Work Order ID 127474

Item Name: Dual High Back Seat Installation

DART SERVICE INSTRUCTION

TO AMEND INSTALLATION INSTRUCTIONS IIN-D350-689 REV. B AND INSTRUCTIONS FOR CONTINUED AIRWORTHINESS ICA-D350-689 REV. 1

FIGURE 1: UPDATES TO CROSS SECTIONS F-F AND M-M
 With reference to Figures 5 and 7 of IIN-D350-689
 (Figures 25-5 and 25-7 of ICA-D350-689)

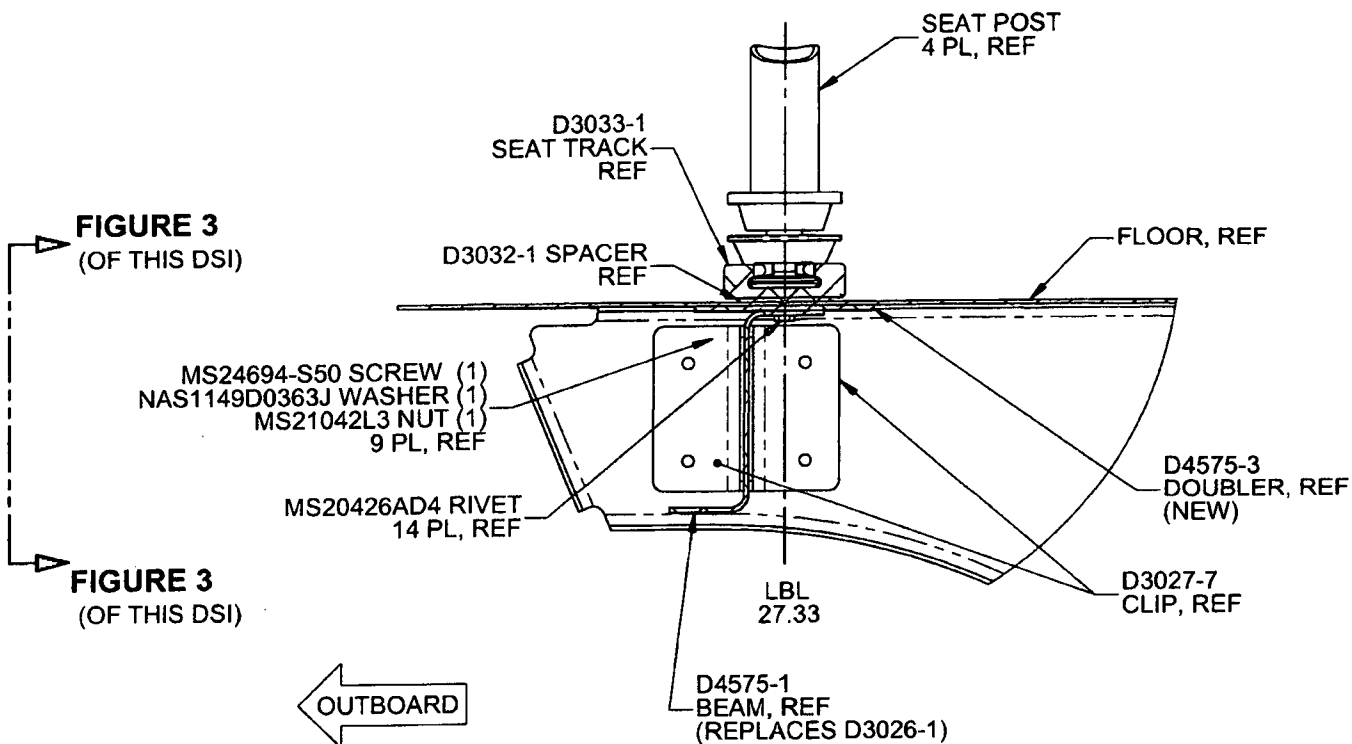
If there is an existing stringer at LBL 27.33, it will need to be removed from that location. Locate D4575-1 Beam, D4575-3 Doubler, and D3032-1 Spacer as shown in Figure 1 of this Service Instruction. Transfer drill existing holes from the aircraft floor to the D4575-1 Beam, D4575-3 Doubler, and D3032-1 Spacer. Ensure 1.0" to 1.5" rivet pitch and add additional holes if required. If there is no existing stringer, locate D4575-1 Beam, D4575-3 Doubler, and D3032-1 Spacer as shown in Figure 1 of this Service Instruction and drill Ø0.128" holes on a 1.0" to 1.5" pitch.

Counter sink holes in the D3032-1 Spacer for MS20426AD4 rivets. Install D4575-1 Beam, D4575-3 Doubler, and D3032-1 Spacer to floor using MS20426AD4 rivets.

If there is an existing stringer at LBL 27.33, it will need to be removed from that location. Locate D4575-1 Beam and D4575-3 Doubler as shown in Figure 2 of this Service Instruction. Transfer drill existing holes from the aircraft floor to the D4575-1 Beam and D4575-3 Doubler. Ensure 1.0" to 1.5" rivet pitch and add additional holes if required. If there is no existing stringer, locate D4575-1 Beam and D4575-3 Doubler as shown in Figure 1 of this Service Instruction and drill Ø0.128" holes on a 1.0" to 1.5" pitch.

FIGURE 2: UPDATES TO FIGURE 21 (IIN-D350-689) AND 25-21 (ICA-D350-689)
 With reference to Figures 19 and 20 of IIN-D350-689
 (Figures 25-19 and 25-20 of ICA-D350-689)

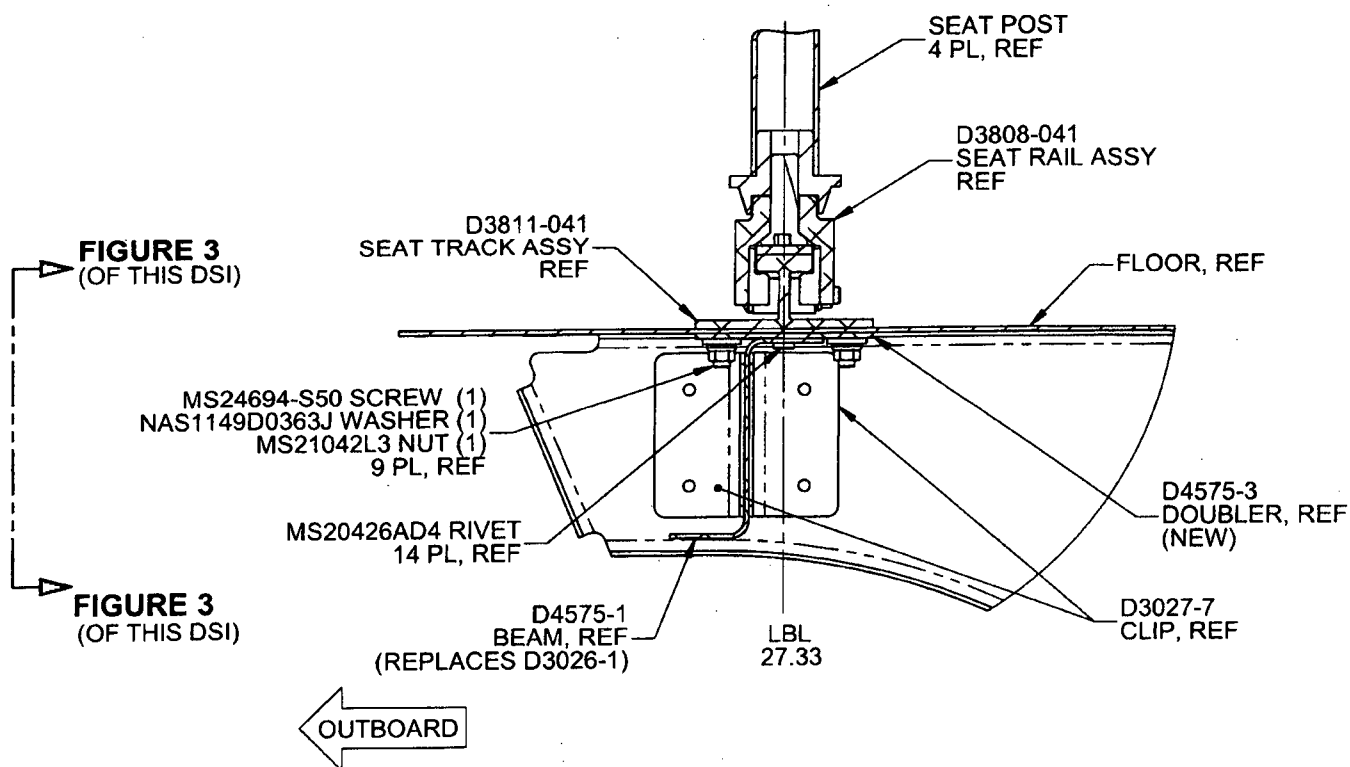
Attach D4575-1 Beam and D4575-3 Doubler to floor using qty (14) MS20426AD4 rivets.

FIGURE 3: RELIEFS ON D4575-1/-3
(ONLY D4575-1/-3 SHOWN FOR CLARITY)
VIEW LOOKING INBOARD

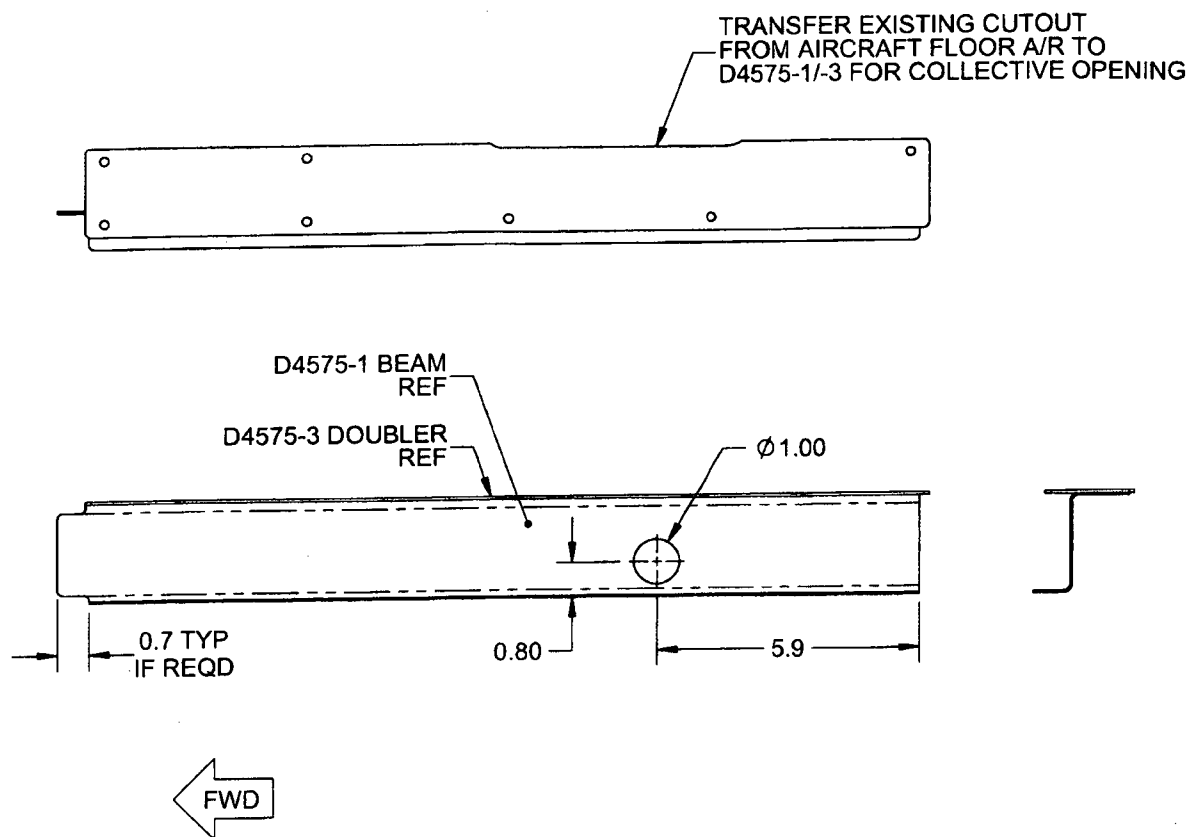
Note: Drill a Ø1.00" (Ø25.4 mm) hole in the D4575-1 Beam to clear extension tube of collective and cutout as required for clearance of collective opening and fwd bulkhead as shown in Figure 3 of this Service Instruction.

Note: Drill a Ø1.00" (Ø25.4 mm) hole in the D4575-1 Beam to clear extension tube of collective and cutout as required for clearance of collective opening and fwd bulkhead as shown in Figure 3 of this Service Instruction.
